TECHNICAL MEMORANDUM

TO: Don Hardy and Brianna Addotta | City of Canby

FROM: Kevin Chewuk | DKS Associates

SUBJECT: Canby NE 3rd Ave Apartments
Transportation Analysis Findings

FIGURE 1: SITE PLAN FOR THE PROPOSED NE 3RD AVE APARTMENTS

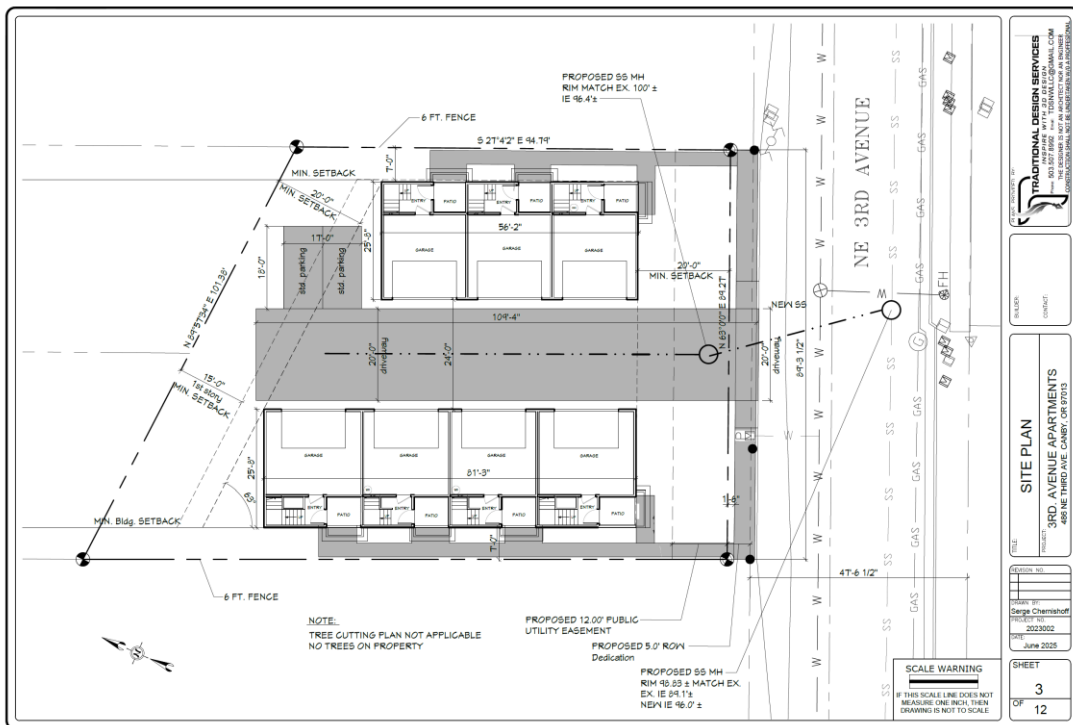
The site proposes adding a driveway from NE 3rd Avenue connecting the new on-site parking drive aisle, as shown in Figure 1. The proposed access will be 20 feet wide, which complies with City access width requirements for residential uses with 3-19 units⁴, with the proposed driveway complying with this standard.

The proposed driveway to NE 3rd Avenue requires a minimum of 280 feet of sight distance based on a 25-mph speed. A preliminary sight distance evaluation from the approximate location of the new driveway indicates that there would be expected sight distance past N Locust Street (about 250 feet) looking to the southwest, suggesting adequate sight distance. Sight distance was not evaluated looking to the northeast since NE 3rd Avenue is a one-way street heading in that direction. Prior to the City conducting the final inspection, sight distance will need to be verified, documented, and stamped by a registered professional Civil or Traffic Engineer licensed in the State of Oregon.

The proposed site plan (shown earlier in Figure 1) shows the site is proposing one driveway to NE 3rd Avenue. The driveway will be paved with a 20 feet drive aisle and provide access to the on-site parking areas for vehicles and bicycles. The proposed driveway access can adequately accommodate vehicle and bicycle circulation to NE 3rd Avenue and internally within the site.

The site plan also includes proposed sidewalk connections from the entrance of each dwelling unit and the parking area to NE 3rd Avenue, complying with City pedestrian access requirements for residential uses with 3-19 units^{7 8}.
